CBD East Alignment Refinement Technical Memorandum

Project: GPC6, C-2012668-02, Task Order #39 Dallas CBD Second Light Rail Alignment (D2 Subway)

Subject: CBD East Alignment Refinement Technical Memorandum

FIGURE 2. LPA CBD East Alignment Area (June 2017)

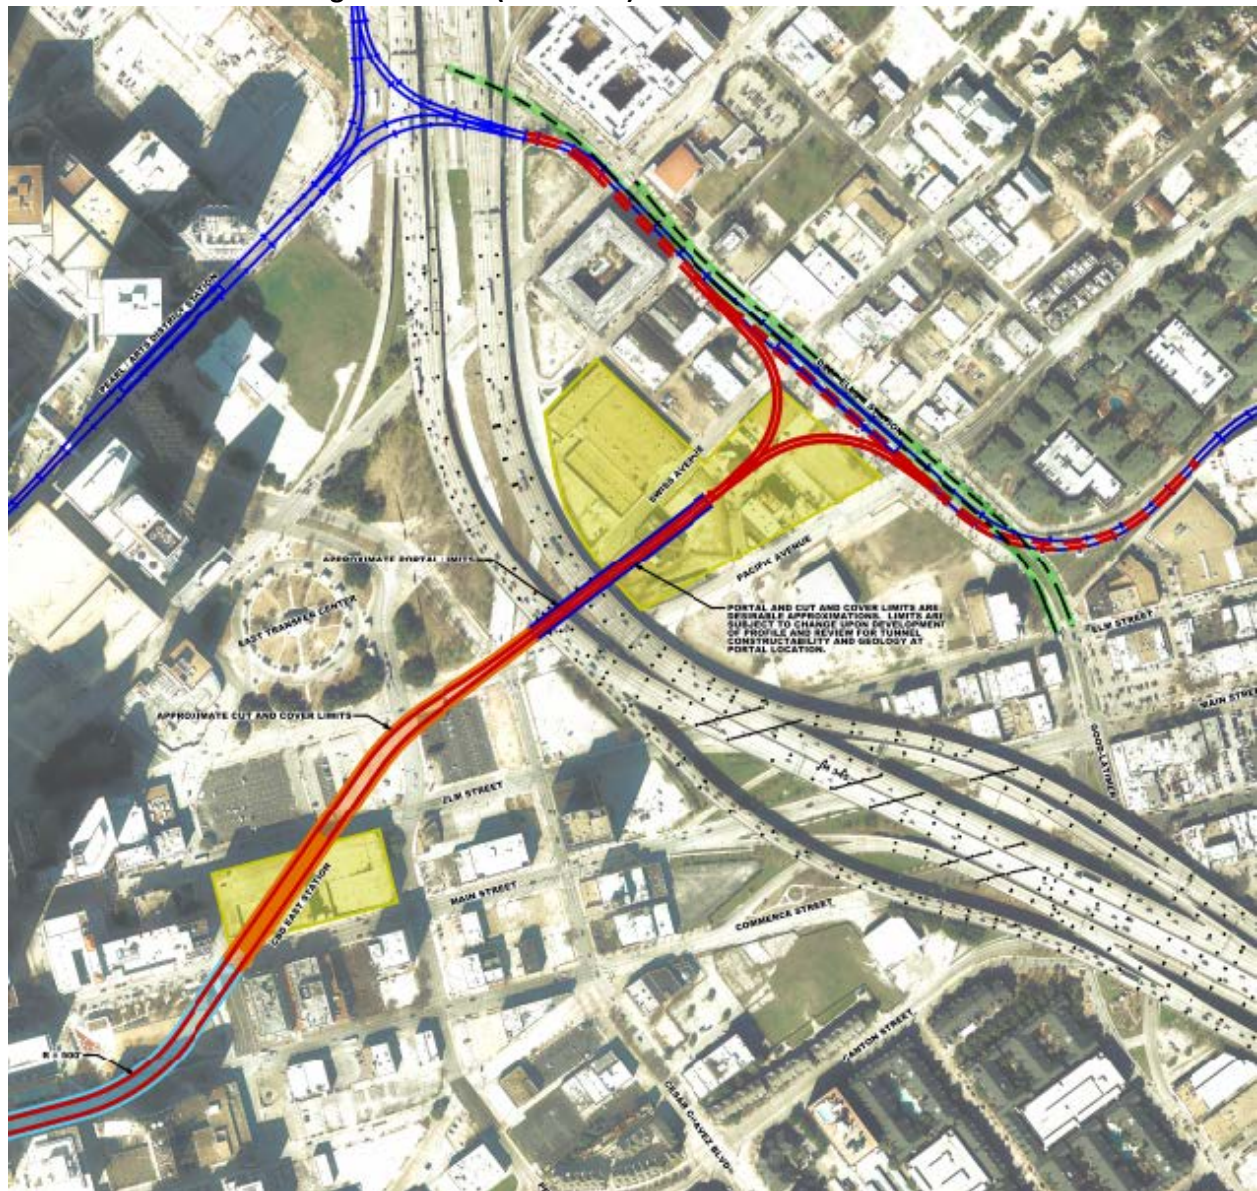
Figure 2 is an enlarged view of CBD East portion of the 2017 LPA alignment, showing the tunnel portion under Main Street Garden (blue shading) and cut-and-cover and mined construction (orange shading) near and under two adjoining Elm Street parking garages. The CBD East station platform would be directly under the western garage and partially under the eastern one, presenting challenges related to construction.

As part of the Methods of Construction Report, a draft technical memorandum was developed to assess construction of the alignment and station under the Elm Street garages assuming use of the Sequential Excavation Method (SEM). The memorandum documented as-built drawings available for one of the garages and recent geotechnical boring data. Three alternatives were considered to address the conflict of the existing building foundations and mined construction of the CBD East Station:

1. Temporary underpinning and building foundation load transfer to station's final lining. This approach is not recommended due to the extensive underpinning that will be required and the magnitude of the loads that will need to be supported by the station's final lining.

2. Permanent underpinning of existing foundations outside the station limits. This requires the use of a permanent framing system and foundations outside the station's limits. This approach is also not recommended since it is considered not practical and of high risk to the existing parking structure.

3. Revising the vertical alignment and relocation of the station. Lowering the vertical alignment and relocating the station in the southwest direction will result in avoiding the underpinning of the existing garage structure and permit the excavation of the station with competent rock cover. Shifting the station and lowering the vertical profile avoids interference with the heavily loaded foundation piers above the station, where the rock cover is less; however, the foundations piers would now be situated above the running tunnel and their impact on the running tunnel will need to be also evaluated. However, shifting the station to the east locates it too close to Commerce Station, and would not be feasible given the alignment curve under Main Street Garden park.

For both underpinning alternatives, in addition to the large number of columns and magnitude of loads that will need to be supported, at least 20 columns would be impacted and could create damages to the existing structure due to extensive structural reframing, jacking and load transfer operations. There would also be time restrictions and parking garage closures to perform the work.

Figure 4. Current D2 Subway Alignment in CBD East Area

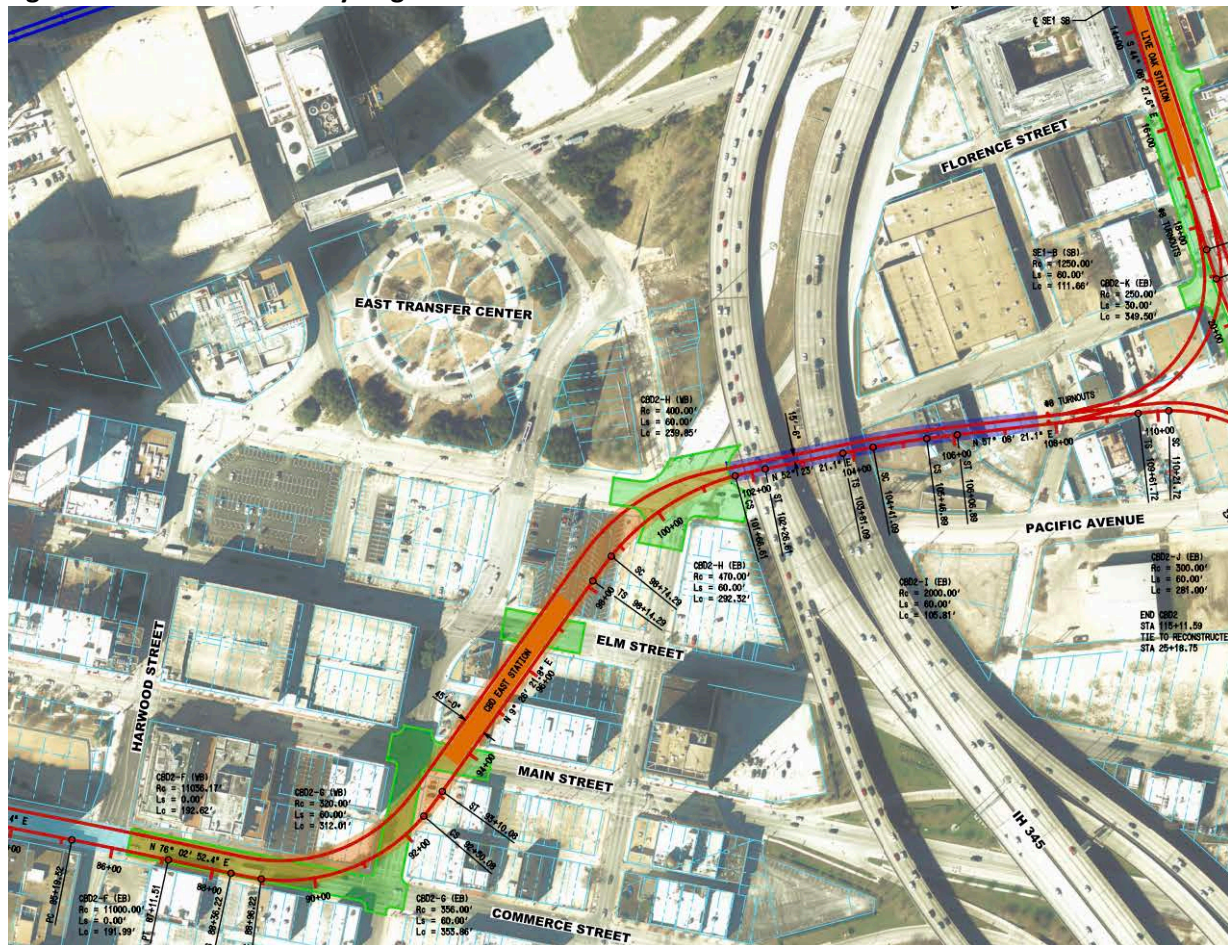
The refined alignment offers several advantages and new opportunities, but also presents new impacts to private property. A summary of key observations with the refinement are as follows:

- Avoids any potential impact to Main Street Garden park.
- Realignment of tunnel and relocation of subway station location avoids any impact to the Elm Street parking garages.

- Cut and cover portion of alignment avoids any potential physical impacts to the planned Carpenter Park improvements.
- Avoids any impact to the large surface parking lots along Main Street immediately to the north of the Elm Street Parking Garages, which have potential development opportunity. However, the refined alignment would impact smaller surface parking lots between Pacific Avenue and Commerce Street. The alignment would still allow for air rights development.

- Acquisition of at least two small buildings at 2107/2109 Main Street (printing business) and 2204 Elm Street (small nightclub) would be required, including relocation of businesses. These structures were surveyed as part of the historic resource documentation.
